Addendum to the Concrete Batch Plant Control Plan

TITLE OF PROJECT: THE NEW NY BRIDGE
CONTRACT NUMBER: D214134

TITLE OF DRAWING
UNIT 2-3 - APPROACHES
PILE CAP & PIER CAP
CONCRETE POUR PLAN
[REDACTED] - PILE CAP

Pipe Pile Seals for 72-inch Diameter Piles:

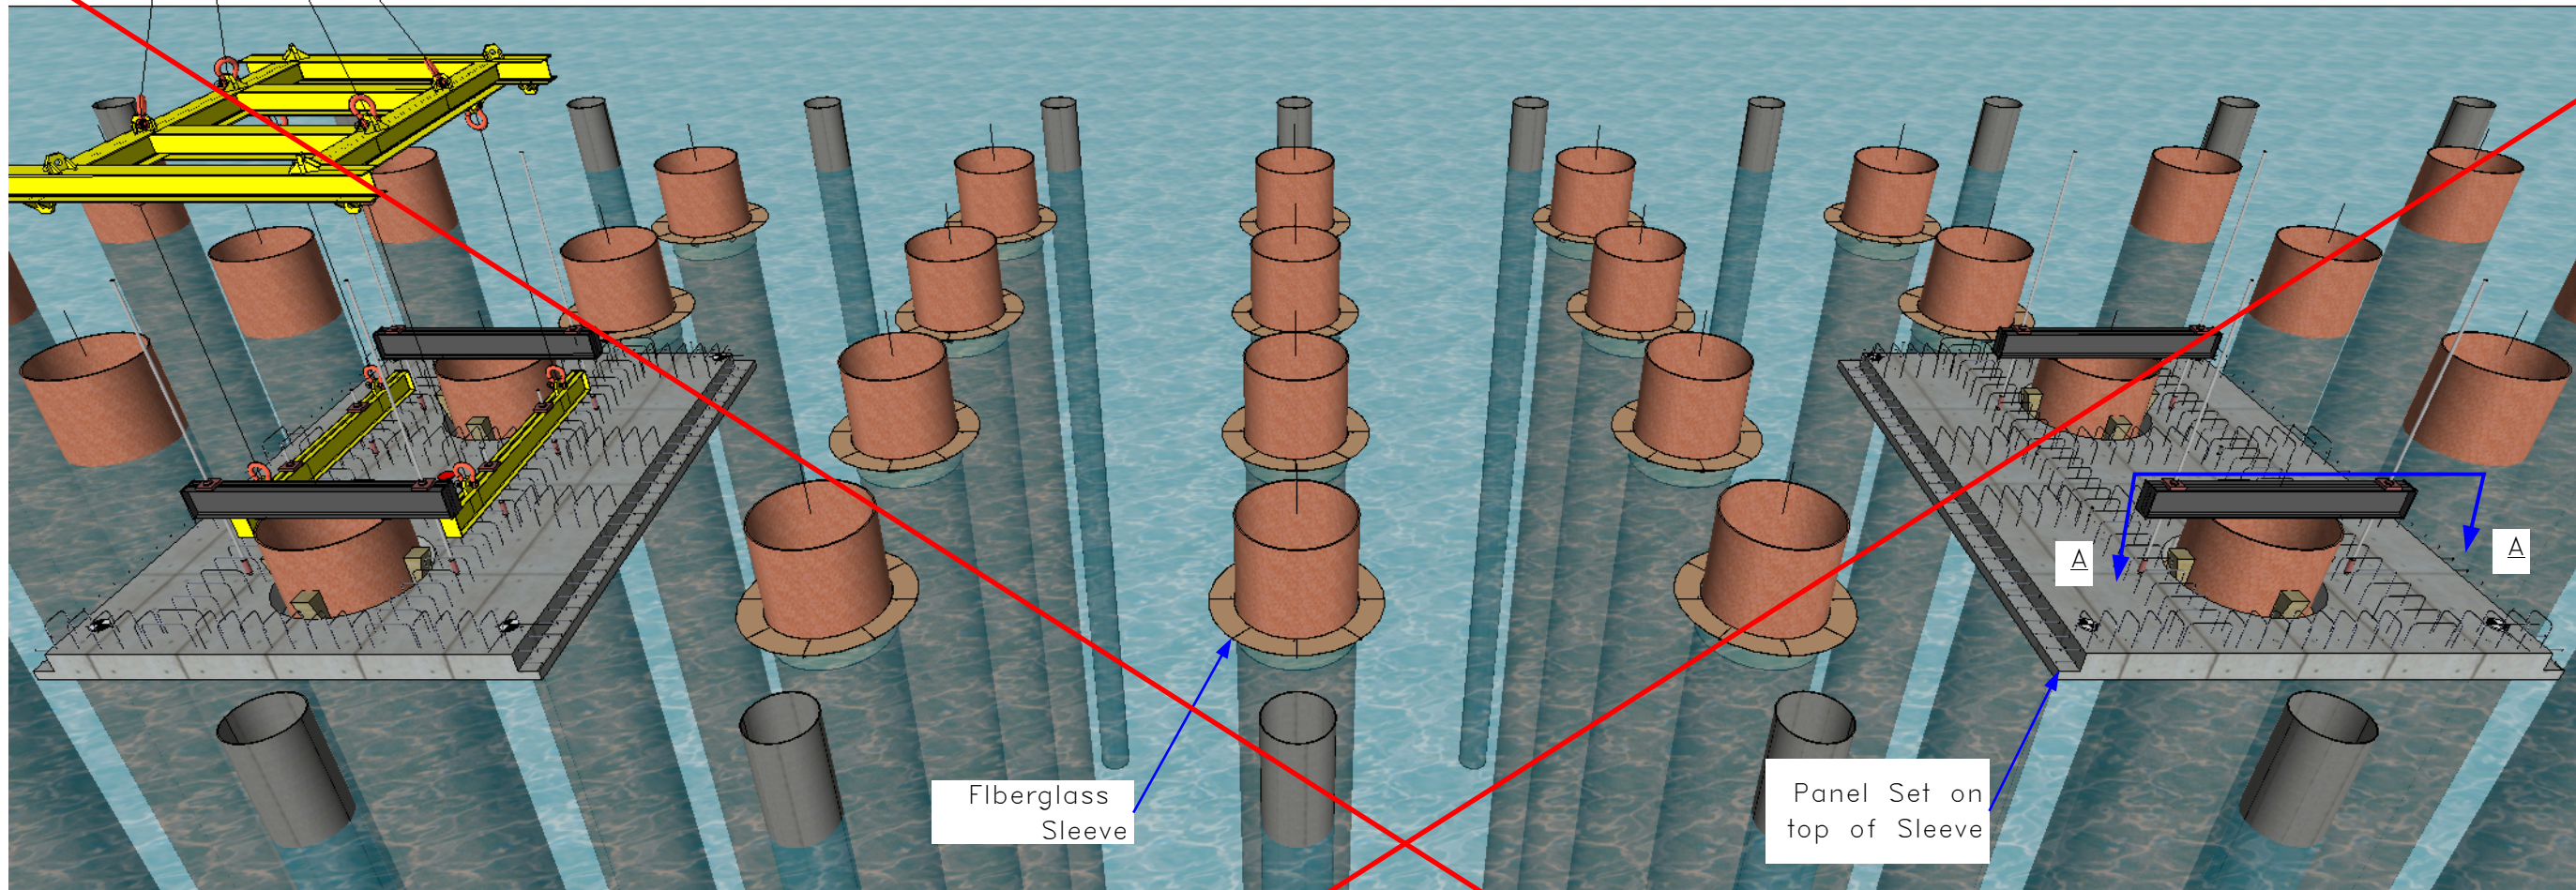
Appendix F of the Concrete Batch Plant Control Plan has been revised to include updated drawings of the  fiberglass sleeves and the soffit panel work plan.

The following procedure will be used to secure the fiberglass sleeves to the pre-cast concrete soffit panels:

1. Preference is to have the fiberglass sleeves set immediately prior to setting pre-cast panels. Sleeves must be secured to pre-cast panels with minimum four of the eight angles before end of shift.

3. Prior to placing concrete the fiberglass sleeve will be inspected using a diver to confirm the fiberglass sleeve is properly placed and affixed to the soffit panel per the plan.
